SUBJECT: VOGTLE ELECTRIC GENERATING PLANT, UNITS 1 AND 2, ISSUANCE OF AMENDMENT NOS. 210 AND 193, REGARDING REVISION TO TECHNICAL SPECIFICATION 3.3.5, "4.16 KV [KILOVOLT] ESF [ENGINEERED SAFETY FEATURE] BUS LOSS OF POWER (LOP) INSTRUMENTATION" (EPID L-2021-LLA-0054)

SAFETY EVALUATION BY THE OFFICE OF NUCLEAR REACTOR REGULATION

The proposed amendments seek to revise the Allowable Values (AVs) for the Loss of Voltage (LOV) and Degraded Voltage (DV) relay voltage settings in TS 3.3.5, "4.16 kV [kilovolt] ESF [Engineered Safety Feature] Loss of Power (LOP) Instrumentation," Surveillance Requirement (SR) 3.3.5.2.

Figure 1: Vogtle Units 1 & 2 DV and LOV Relay AVs NTSs Relationships and Margins Calculations by NRC Staff

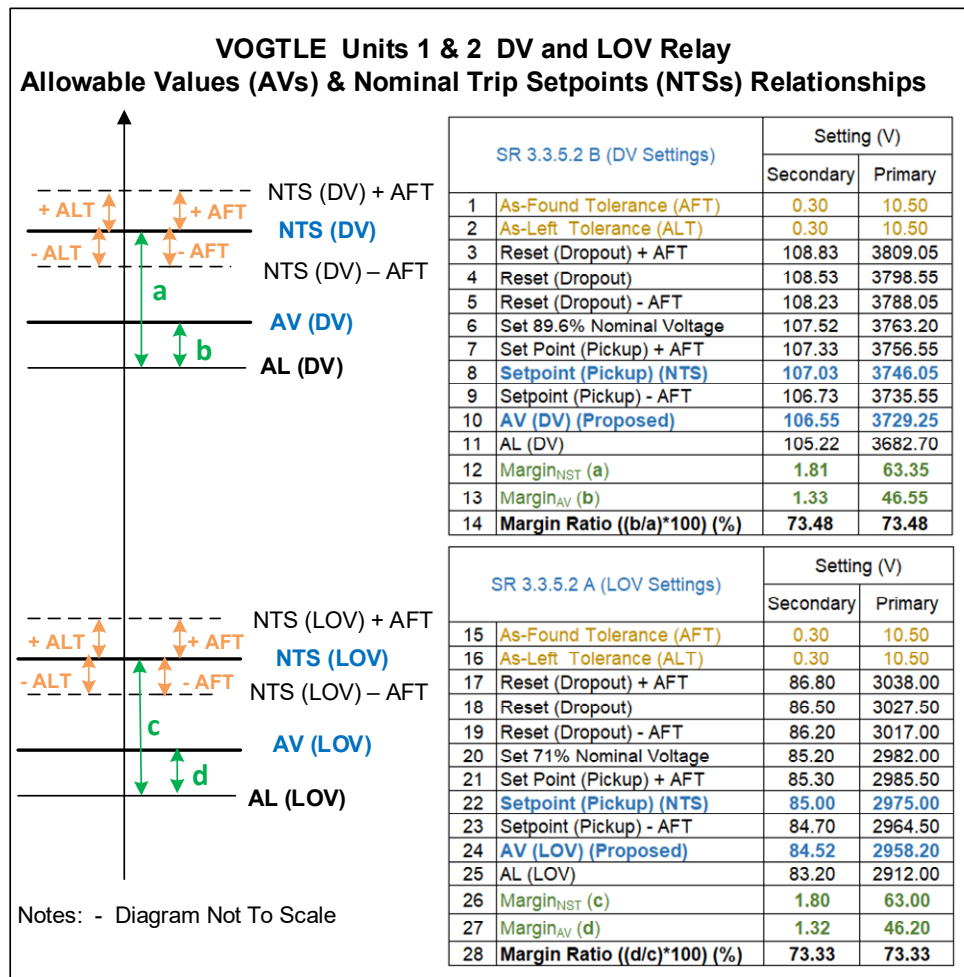
Based on its review as summarized in Figure 1 above, with respect to the proposed AVs for the DV and LOV relays in TS SRs 3.3.5.2 A and 3.3.5.2 B, the NRC staff has determined the following:

- The minimum Reset (Dropout) values of the DV and LOV (Rows 5 and 19) are greater than their maximum Setpoint (Pickup) values (Rows 7 and 21). Therefore, there is adequate separation between the pickup and dropout setpoints.

- The NTSs (Pickup) of DV and LOV inclusive of their AFTs (Rows 9 and 23) are greater than the AVs of DV and LOV (Rows 10 and 24), and therefore, would assure that the trip signals from the DV circuit and/or from LOV circuit would be initiated prior to exceeding their AV values.

- The undervoltage two-out-of-four logic is provided to allow load shedding and tripping of the incoming breaker. These devices are set to operate with a time delay (of ≤ 0.8 s for DV and ≤ 20 s for LOV (no change)) at the proposed minimum of 89.6-percent (for DV) and 71-percent (for LOV) of nominal voltage. These proposed settings are greater than the minimum settings in Chapter 7 of the Vogtle FSAR (88.5-percent (for DV) and 70-percent (for LOV). Therefore, the proposed settings would be below the minimum expected voltage during the DG sequencing and would prevent the unwanted tripping and undervoltage induced damage to the safety-related loads.

- The ratio between the NTS and AV margins are greater than 73-percent (Rows 14 and 28) and are adequate. These margins ensure that the trip setpoints have been chosen to assure that a trip or safety actuation will occur well before the measured process reaches the Lower Analytical Limits (Minimum Equipment Acceptable Voltage). Therefore, the proposed AV settings support an automatic protective action before a safety limit is exceeded.

Based on the above, the NRC staff finds that the proposed DV and LOV relay settings (minimum AVs) for SR 3.3.5.2 A and SR 3.3.5.2 B in TS Section 3.3.5 maintain adequate AV margins, consistent with RG 1.105, and continue to satisfy the requirements of GDC 13. The NRC staff further finds the requirements of 10 CFR 50.36(c)(1)(ii)(A) and 10 CFR 50.36(c)(3) will be met, because automatic protective action will correct the abnormal situation before a safety limit is exceeded and the SR will assure that the necessary quality of systems and components is maintained, that facility operation will be within safety limits, and that the limiting conditions for operation will be met. Therefore, the proposed AVs are acceptable.
